COUNCIL ASSESSMENT REPORT

SYDNEY EASTERN CITY PLANNING PANEL

PANEL REFERENCE & DA NUMBER	PPSSEC-296 DA2023/0222
PROPOSAL	Construction of a 37-storey shop-top housing development containing 244 apartments, retail/commercial premises at the podium levels, and 9 basement car parking, with associated landscaping.
ADDRESS	No 9 -13 Blaxland Road, Rhodes
APPLICANT	BBG MANAGEMENT PTY LTD (Billbergia)
OWNER	LEEDS INVESTMENT NO. 9 PTY LTD RHODES STATION PROPERTY PTY LIMITED RHODES INVESTMENTS GROUP PTY LTD
DA LODGEMENT DATE	12-Oct-2023
APPLICATION TYPE	DA, INTEGRATED under the <i>Water Management Act</i>
REGIONALLY SIGNIFICANT CRITERIA	The development's estimated cost is more than \$30 million. As outlined in Section 2 of Schedule 6 of the State Environmental Planning Policy (Planning Systems) 2021 (PSSEPP), the DA has declared a regionally significant development under Section 2.19 of the PSSEPP.
CIV	\$168,084,273 (excluding GST)
CLAUSE 4.6 REQUESTS	<ul style="list-style-type: none"> • Clause 4.3 of Canada Bay Local Environmental Plan 2013 (CBLEP) relates to the maximum height requirements • Clause 7.6 of the CBLEP regarding building podiums in Rhodes Precinct

Figure 10 | Height analysis in comparison with maximum standard height plane (Source: Applicant's Clause 4.6 variation request)

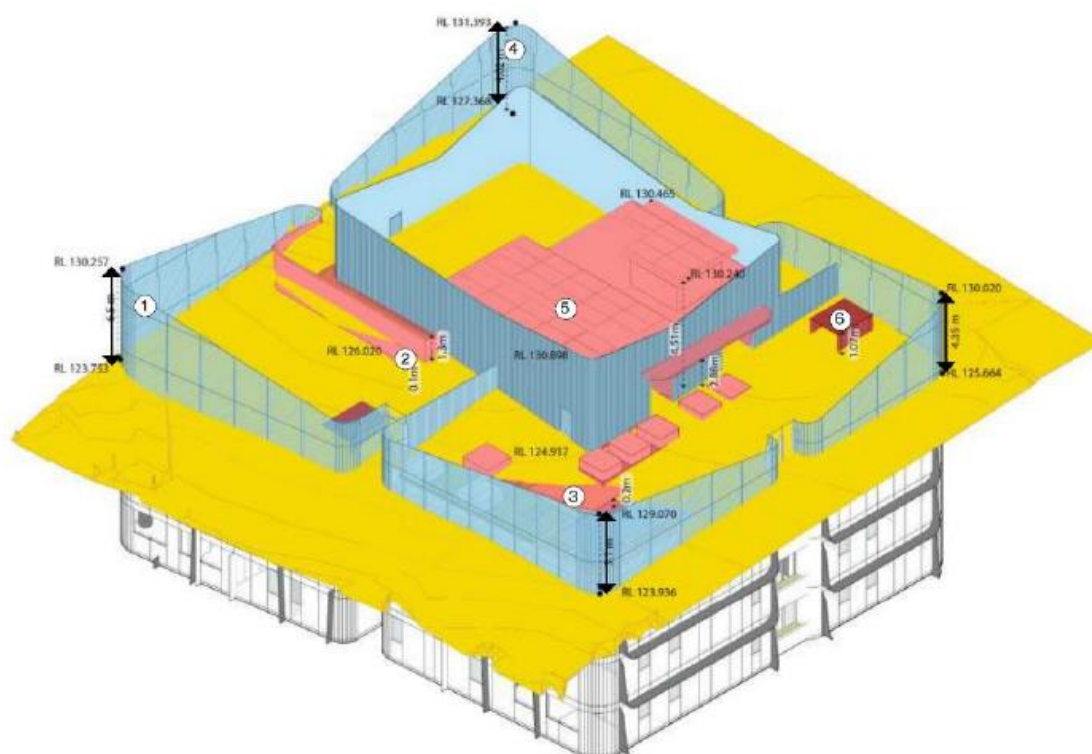
3.1.1.1 To Clause 4.3 Height of buildings

Figure 10 and **Table 5** Indicate the extent of the proposal's non-compliance with the planning control for the height of buildings.

It is assessed that, in satisfaction of s4.6(3)(b), there are sufficient environmental planning grounds to justify the non-compliance, as the development achieves better outcomes through:

- Enhanced architectural and urban design, as the non-compliant elements (enclosed plant, lift overrun, and a cabana) ensure sustainable design and equitable access without resulting in adverse environmental impacts.
- Improved residential amenity for the users of the proposed communal open space area on the roof.

Figure 11 | Tower and Podium Design control diagrams (Source: Canada Bay DCP)

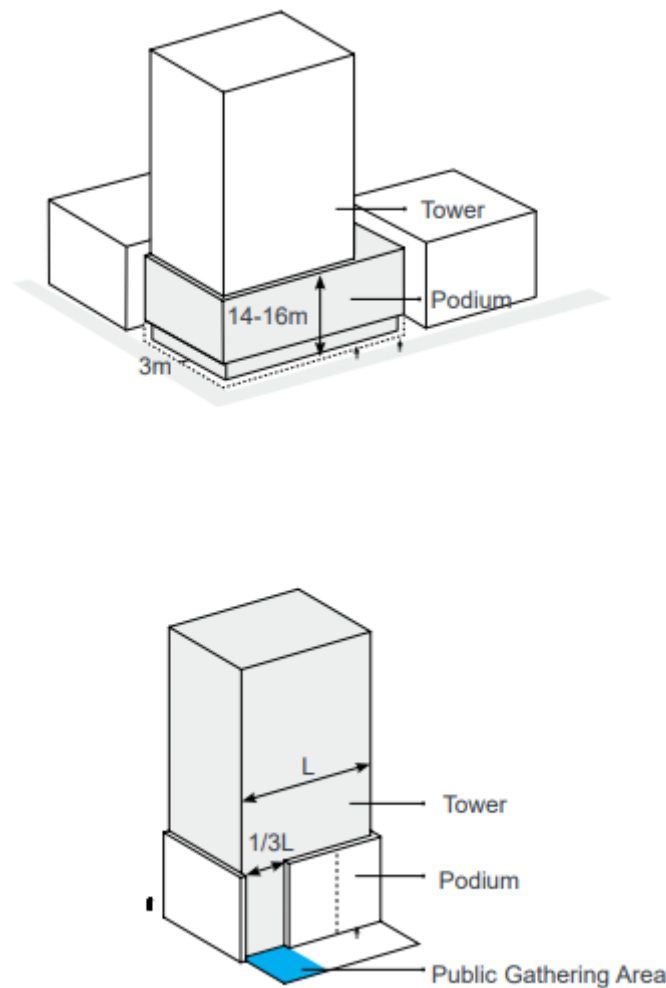
The proposal is situated within the Station Gateway East character area. An assessment of the proposed development against the relevant provisions of the DCP indicates that it is generally consistent with these provisions. However, it does not comply with controls C4 and C5 regarding tower and podium design. The DCP controls and diagrams are as follows (refer to [Figure 11](#)). The not compliance has been discussed and justified in the section [3.1.1.2](#) of this report.

- *C4. A minimum podium height of approximately 14-16m building height is required.*
- *C5. A tower and podium building typology is required, subject to the following outcomes: a) A ground floor setback of 3m is to be provided. b) A Podium to Tower setback of 4m is to be provided. c) Maximum 1/3 of a tower frontage along a street or public space can be extended down to the ground. Public gathering areas must be associated with the 2/3 of the facade that is grounded by a podium.*
